Fiat Stilo with petrol engine

Noise from valve of activated carbon canister

Bulletin

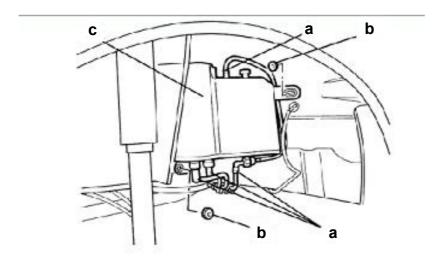
With the above-mentioned vehicles, noise can sometimes be heard coming from the rear right-hand side of the vehicle when on bumpy roads. The noise is usually caused by a metal ball inside the multi-function valve of the activated carbon canister. The only way to solve the problem is to replace the complete activated carbon canister including the integrated multi-function valve. If a replacement has already taken place, there will be a white spot of paint on the head of the lower attachment screw of the fuel tank flap.

The activated carbon canister (see illustration, item c) is at the rear right-hand side of the wheel housing. For dismantling, the hoses (see illustration, items marked "a") and the attachment nuts (see illustration, items marked "b") have to be removed.
